**SUBJECT: Transmittal of Fort Calhoun Station (FCS) Core Operating Limit Report (COLR) Revision 25**

**TDB-VI**

**Title:** CORE OPERATING LIMIT REPORT

FC-68 Number: EC 29235

FIGURE  
7

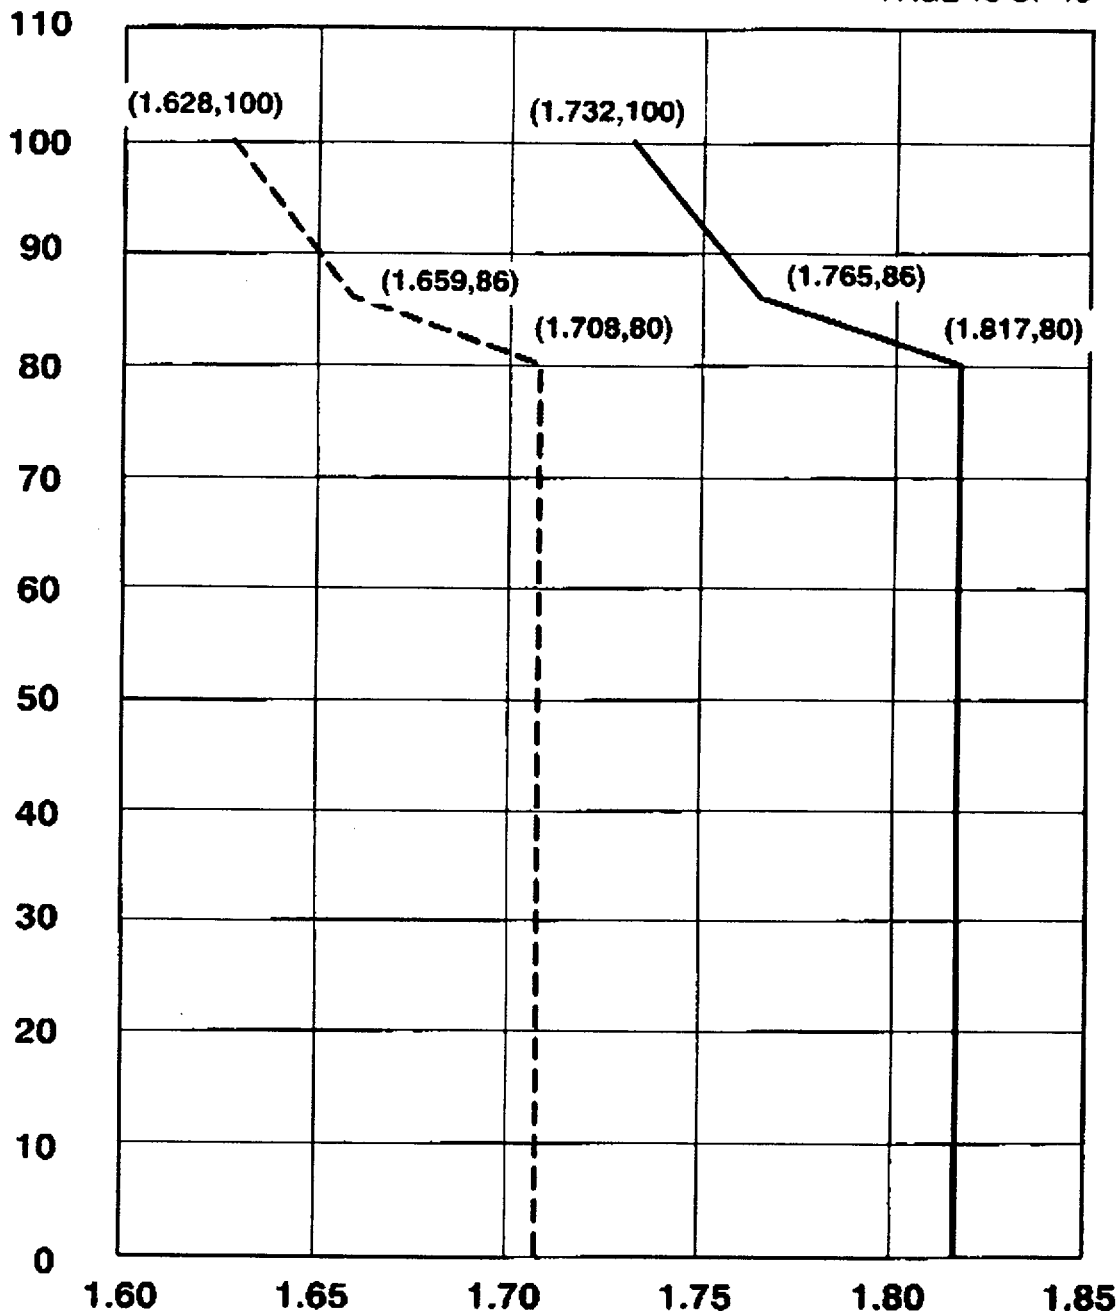
Reason for Change: To allow for operating in the presence of a hot leg flow streaming event of up to 6% deviation.

The Cycle 20 maximum full power value for the integrated radial peaking factor ( $F_{R}^T$ ) is 1.732. An additional dotted line exists on Figure 7 to allow operation in the presence of a hot leg flow streaming event with less than a 6% power difference between actual power and  $\Delta T$  power indication.

- $F_R^T$  Limit with no hot leg flow streaming event in progress
- - - - -  $F_R^T$  Limit if a hot leg flow streaming event is in progress with differences between actual power and  $\Delta T$  power indication of less than 6% power
